CONTRACT CHANGE ORDER NO. 37S01
SHEET 3 OF 11

SAN FRANCISCO OAKLAND BAY BRIDGE
EAST SPAN SEISMIC SAFETY PROJECT
SELF-ANCHORED SUSPENSION BRIDGE
(SUPERSTRUCTURE & TOWER)

MARK	DATE	DESCRIPTIONS	BY	CH'D	CCO#
1	01/28/11	MISCELLANEOUS CABLE SYSTEM DETAILS	GB	MN	37S1

EAST CABLE ANCHORAGE "E" LINE LAYOUT NO. 3

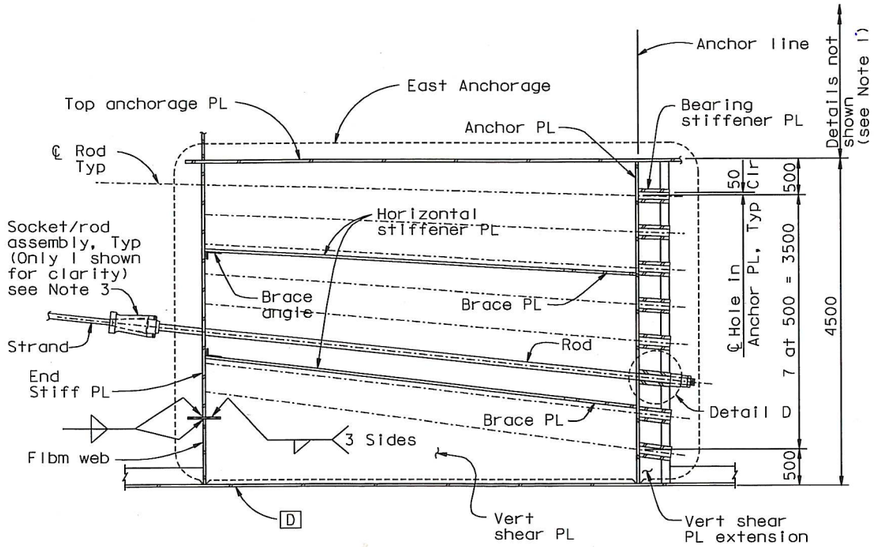
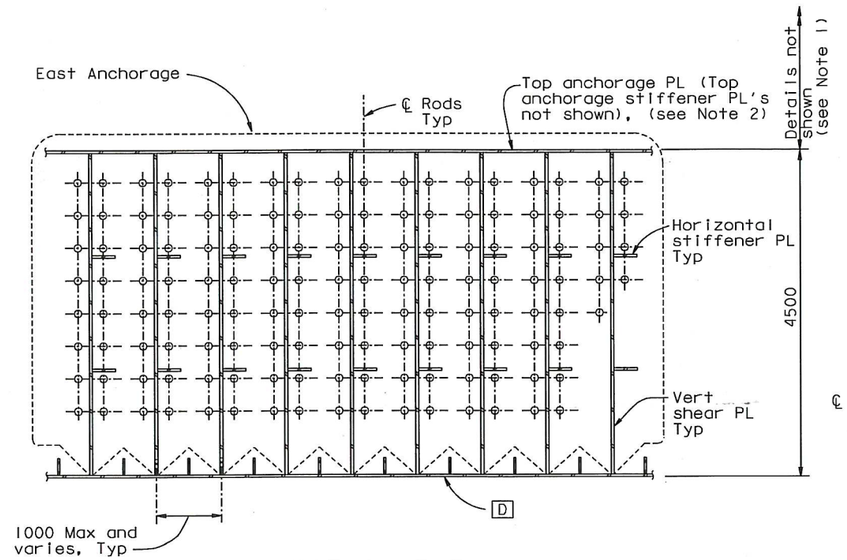
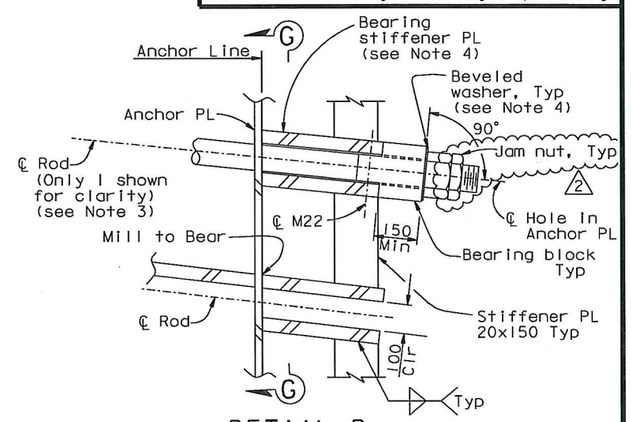
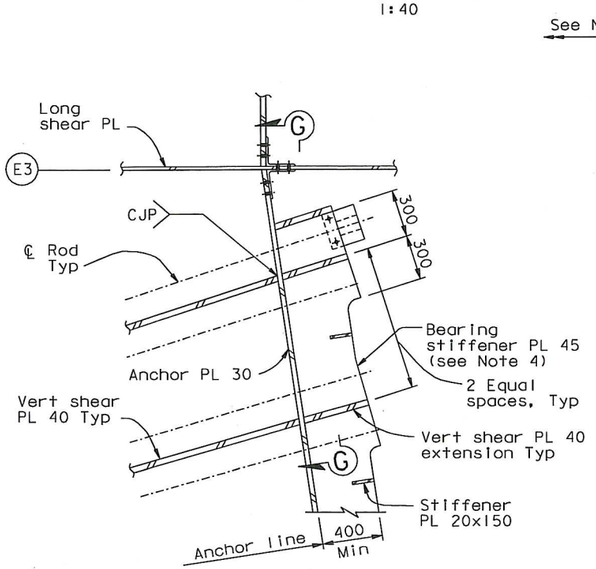
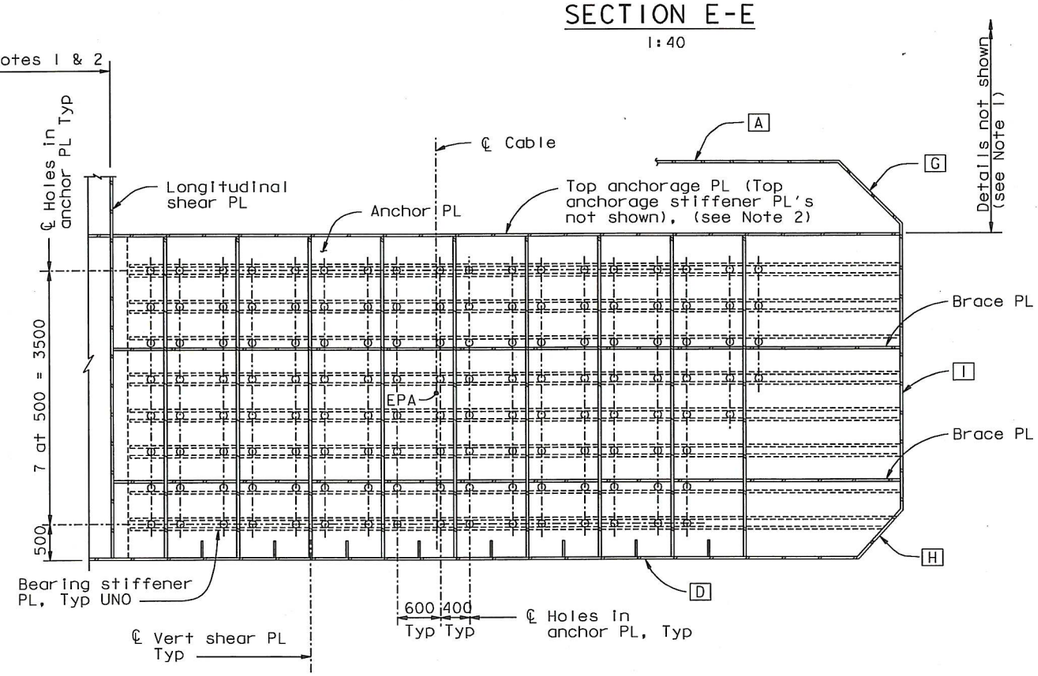
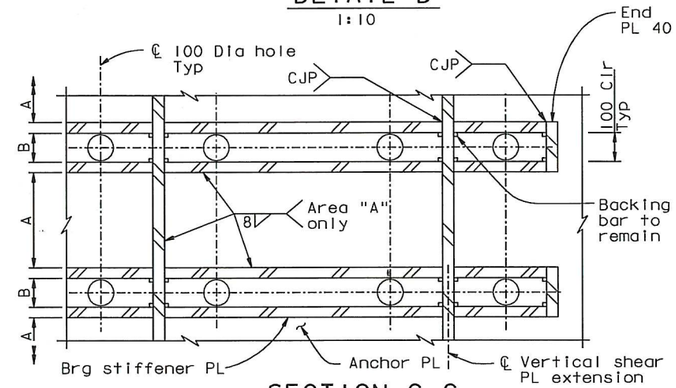
MARK	DATE	DESCRIPTIONS	BY	CH'D	CCO#
2	01/28/11	MISCELLANEOUS CABLE SYSTEM DETAILS	DT	GB	37SI
1	08/28/09	BEARING BLOCKS	DT	GB	78

SAN FRANCISCO OAKLAND BAY BRIDGE
EAST SPAN SEISMIC SAFETY PROJECT
SELF-ANCHORED SUSPENSION BRIDGE
(SUPERSTRUCTURE & TOWER)
EAST CABLE ANCHORAGE "W" LINE LAYOUT NO. 2

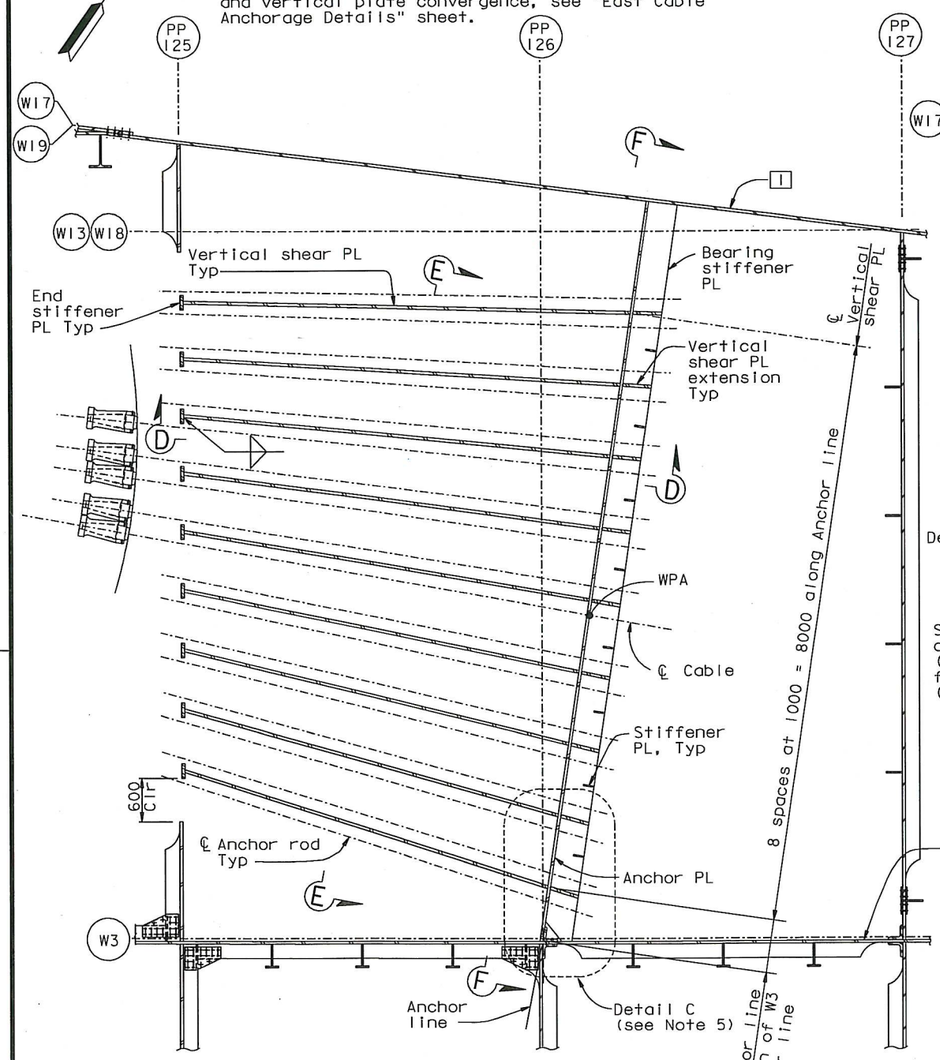
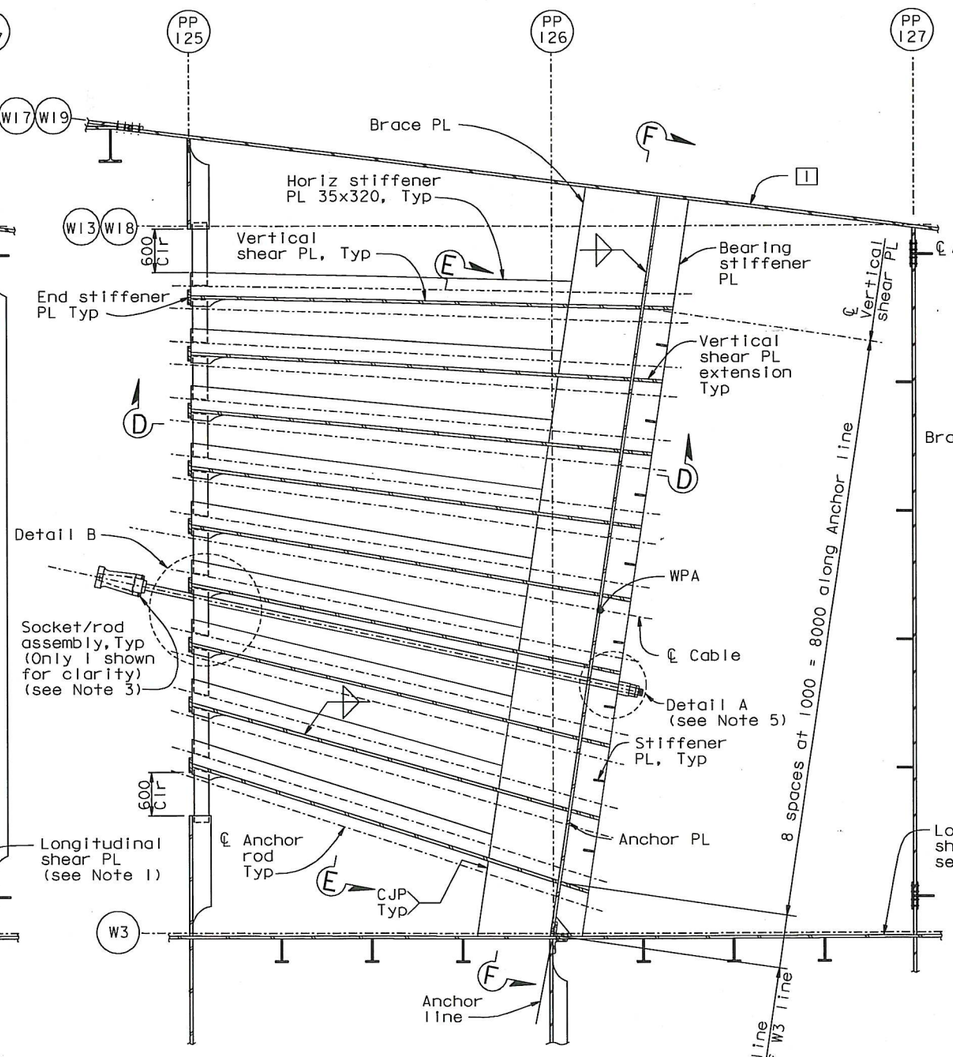
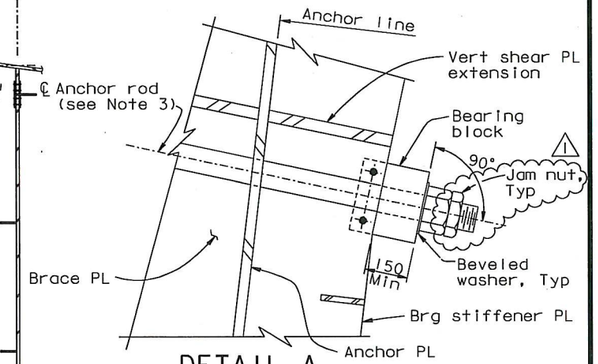
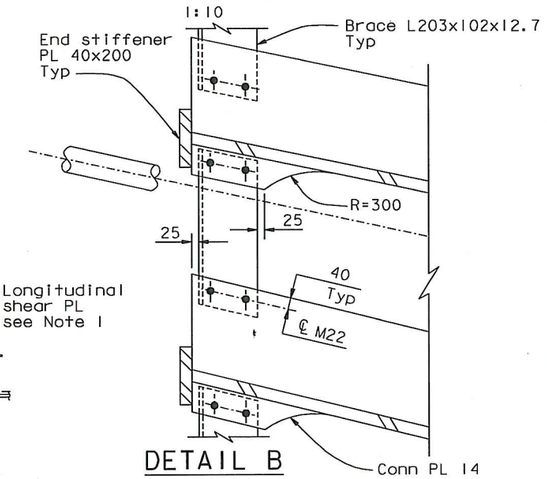
MARK	DATE	DESCRIPTIONS	BY	CH'D	CCO#
1	01/28/11	MISCELLANEOUS CABLE SYSTEM DETAILS	GB	MN	37S1

SAN FRANCISCO OAKLAND BAY BRIDGE
EAST SPAN SEISMIC SAFETY PROJECT
SELF-ANCHORED SUSPENSION BRIDGE
(SUPERSTRUCTURE & TOWER)
EAST CABLE ANCHORAGE "W" LINE LAYOUT NO. 3

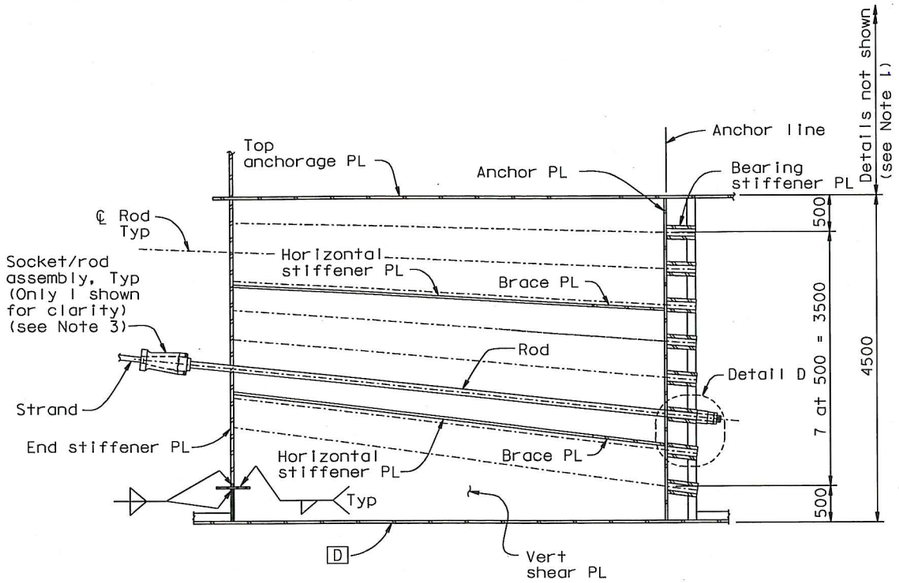
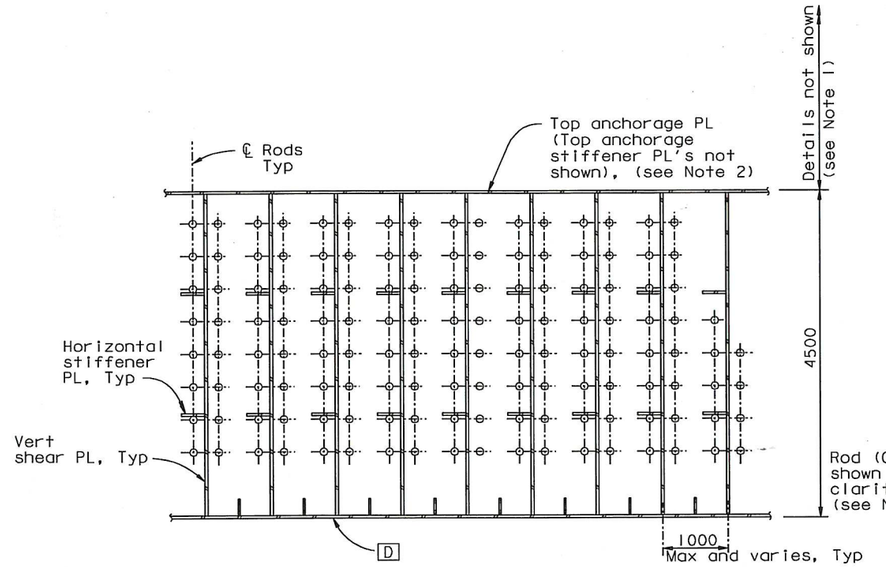
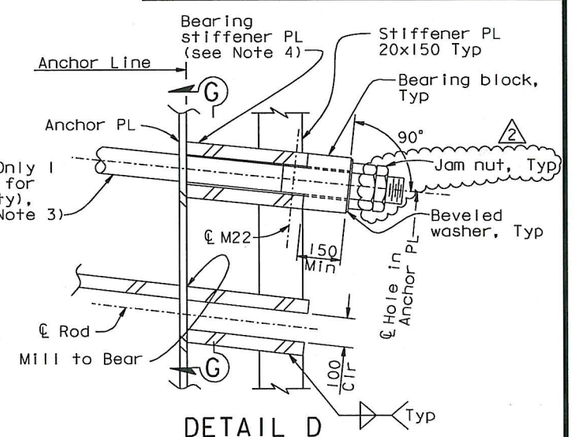
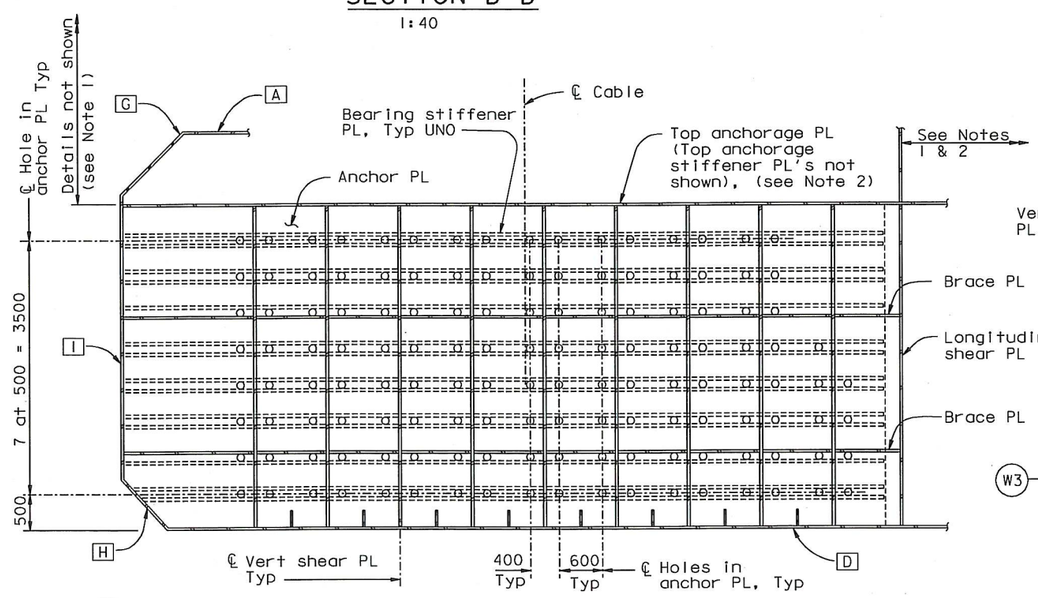
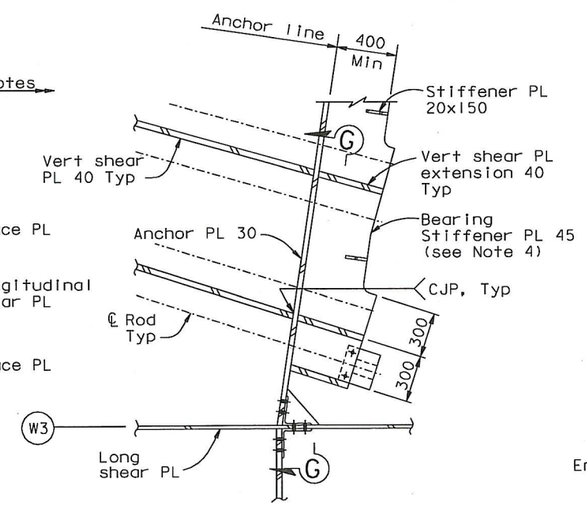
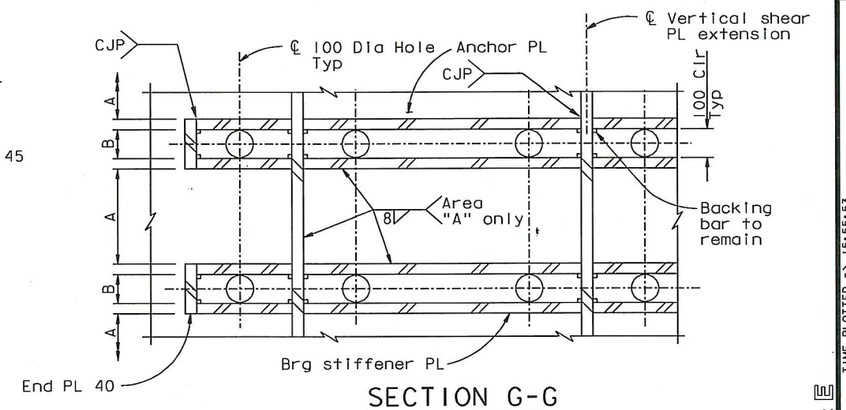
MARK	DATE	DESCRIPTIONS	BY	CH'D	CCO#
2	01/28/11	MISCELLANEOUS CABLE SYSTEM DETAILS	DT	GB	37S1
1	08/28/09	BEARING BLOCKS	DT	GB	78

EAST CABLE ANCHORAGE DETAILS

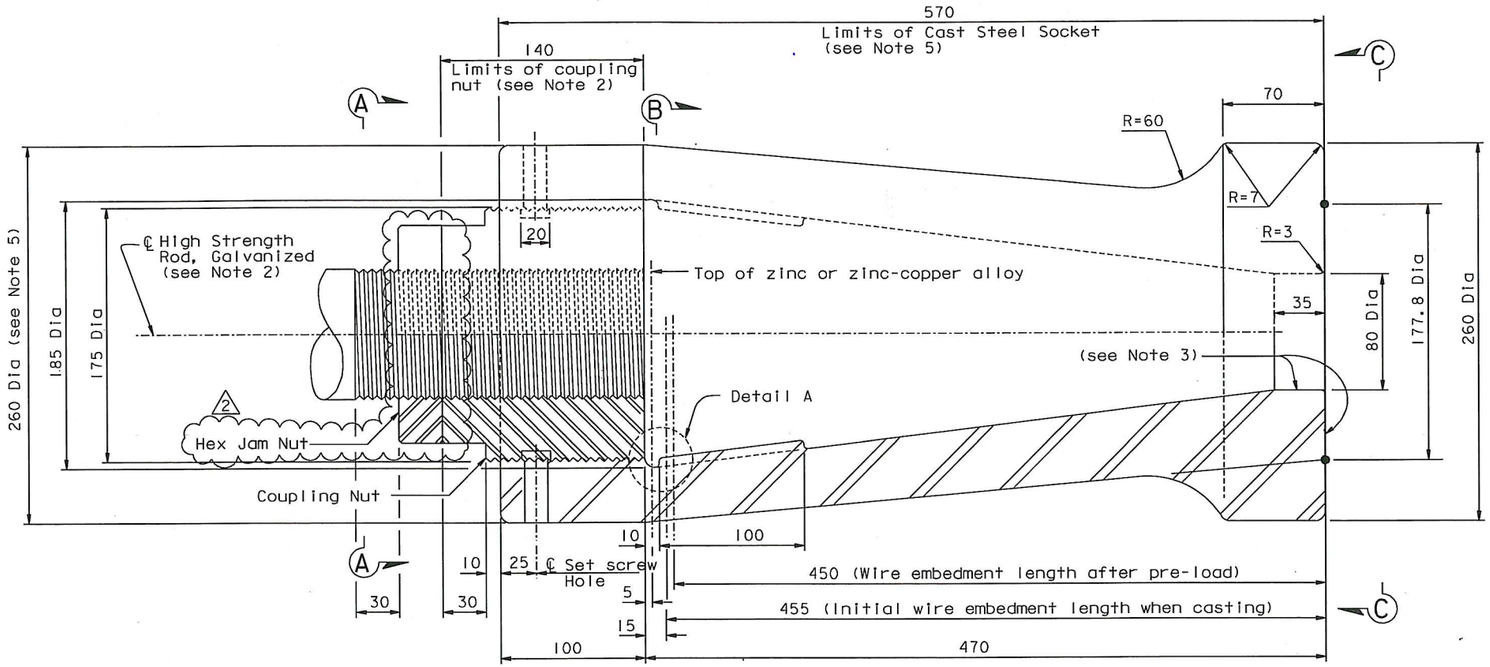
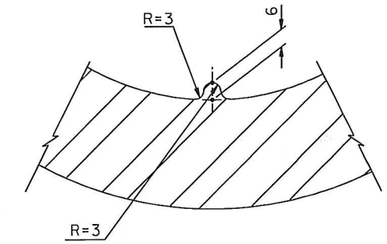
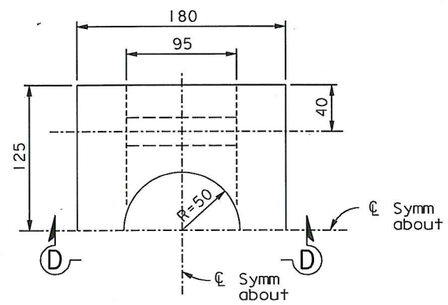
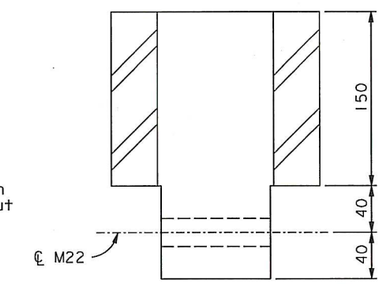
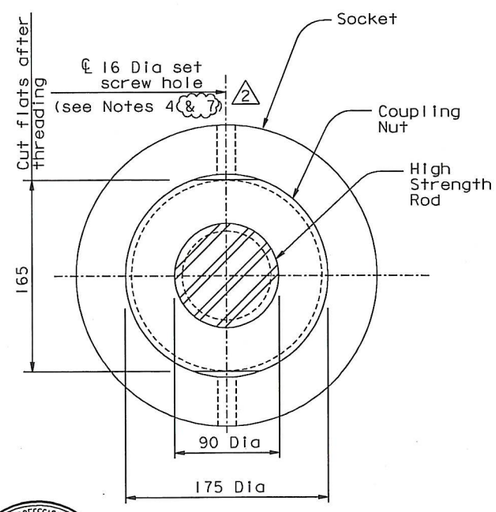
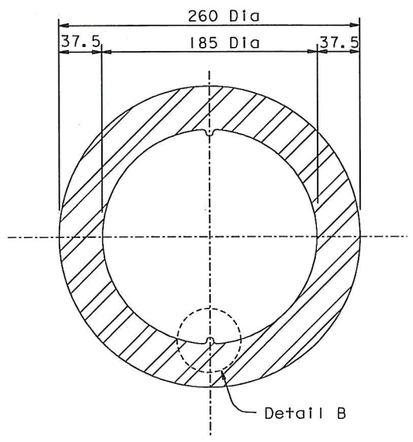
MARK	DATE	DESCRIPTIONS	BY	CH'D	CCO#
2	02/18/11	MISCELLANEOUS CABLE SYSTEM DETAILS	DT	GB	37SI
1	08/28/09	BEARING BLOCKS	DT	GB	78

CABLE BRACKET DETAILS NO. 1

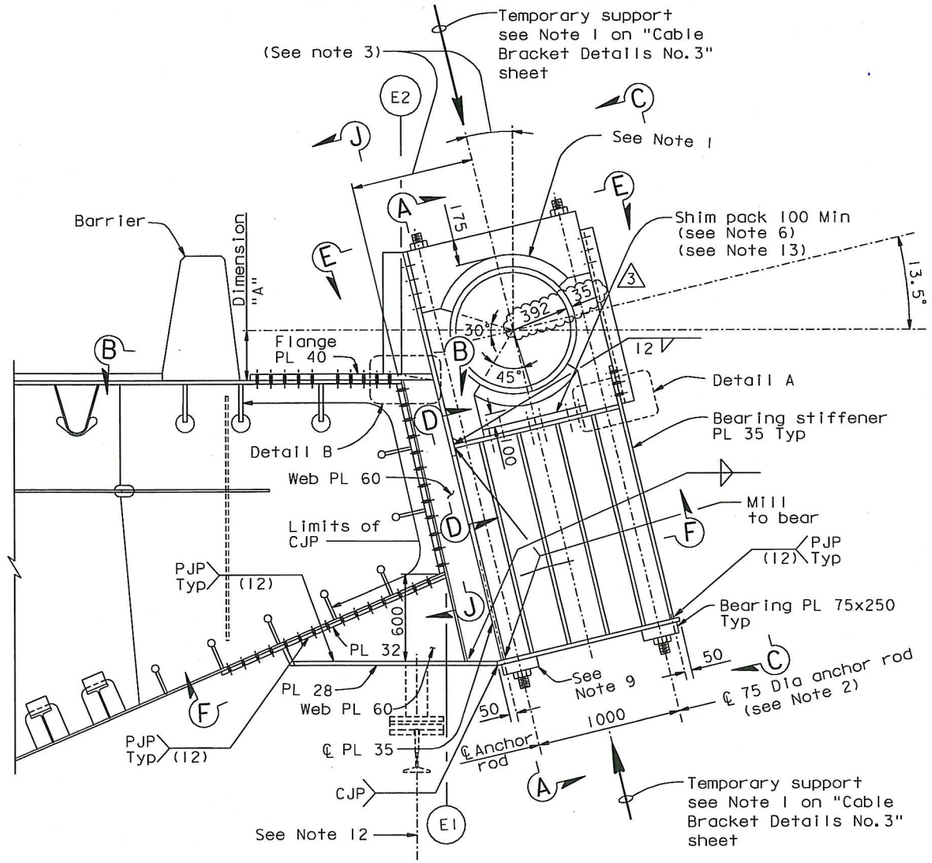
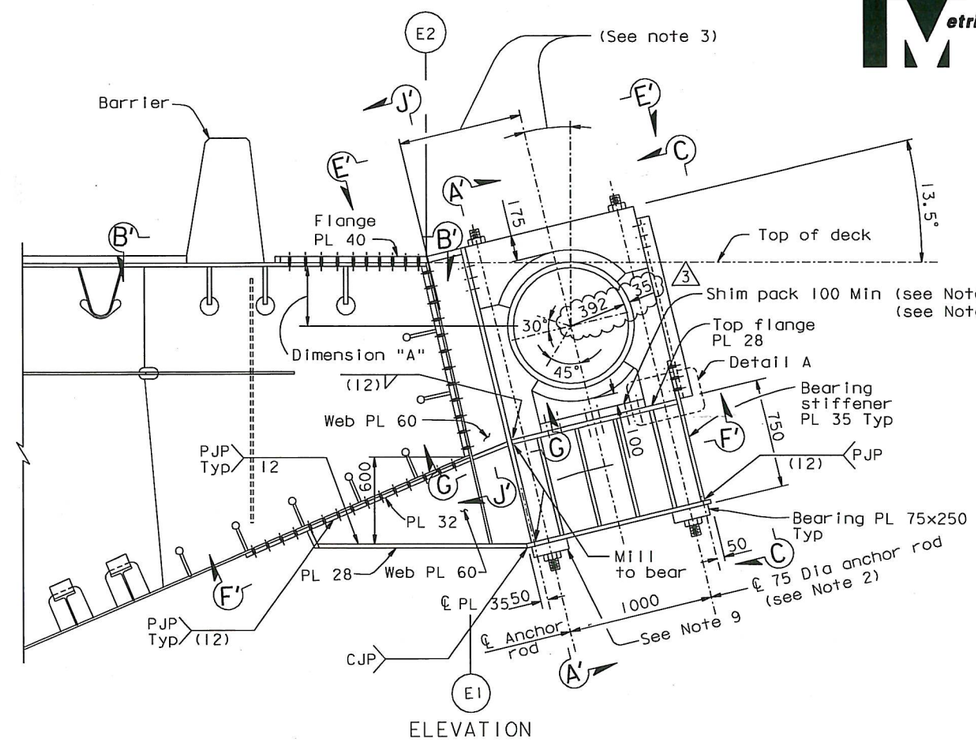
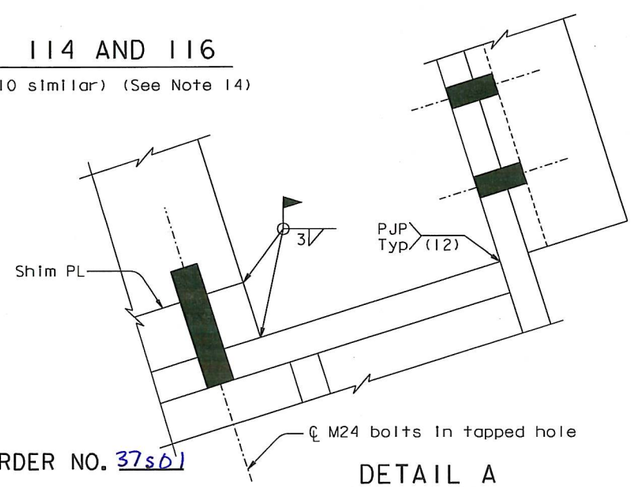
MARK	DATE	DESCRIPTIONS	BY	CH'D	CCO#
3	01/28/11	MISCELLANEOUS CABLE SYSTEM DETAILS	GB	MN	37S1
2	12/18/09	SUSPENDER BRACKETS	GB	MN	104
1	02/20/09	SUSPENDER BRACKETS	GB	MN	104
